SERVICE BULLETIN

SB-080323-B

ID NUMBER & REVISION: SB-080323-B
SUBJECT: Nose Landing Gear Limit Switch Retrofit
RELEASE DATE: 20 November 2023
EFFECTIVE DATE: 20 November 2023
SUPERSEDES NOTICE: SB-080323-A
AIRCRAFT AFFECTED: **MAKE & MODEL:** ICON A5
SERIAL NUMBERS: 00001-00015, 00018-00033, 00035-00036, 00038-00072, 00074-00086, 00088-00182, 00184-00188

REQUIRED ACTION: Retrofit reed switch style NLG actuators with non-magnetic limit switches.
Note: If this Service Bulletin was previously complied with under revision A, no further action is needed.

Figure 1. Bracket Modifications for 10-32 Studs

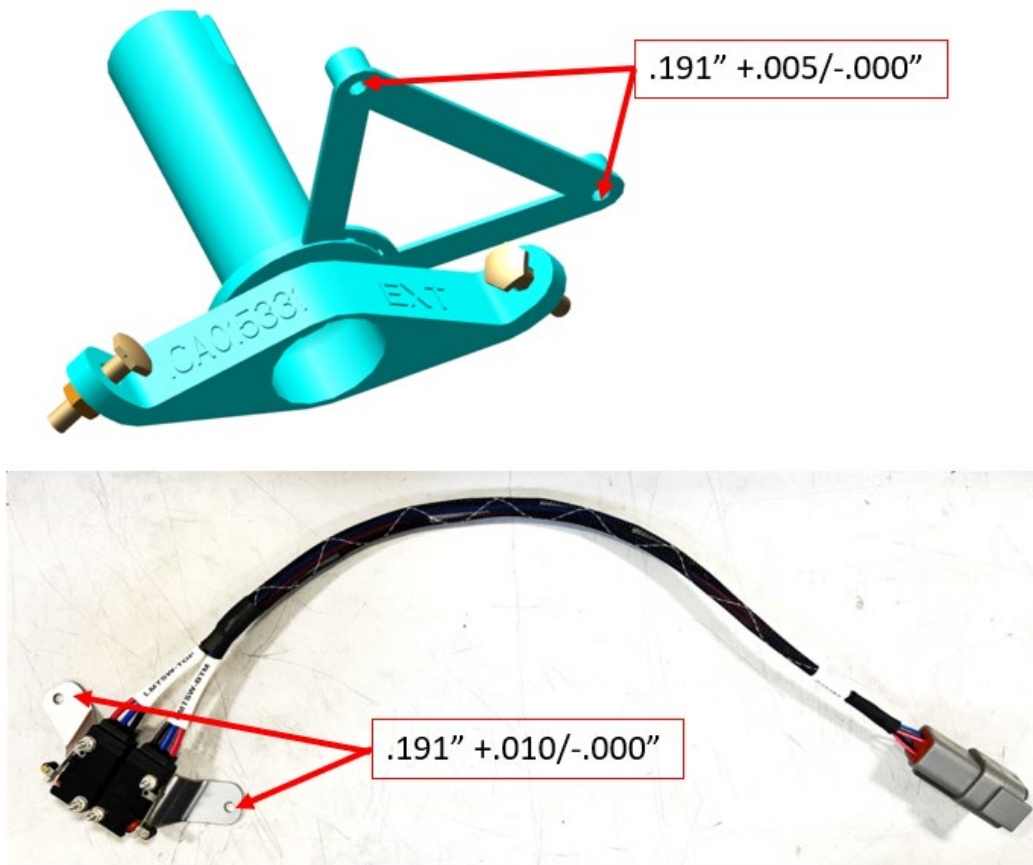
Bracket Modification Instructions

If using either kit with 10-32 studs (ME001168 or ME001188), complete the following bracket and tool modifications. (If using 8-32 studs, continue to INSTRUCTIONS.)

1. Drill the 2x holes in the Limit Switch Bracket Fixture (part of ME001175) to .191" +.005/-.000".
2. Drill the 2x holes in the Limit Switch Subassy Bracket (ME001143 or part of ME001168) to .191" +.010/-.000".
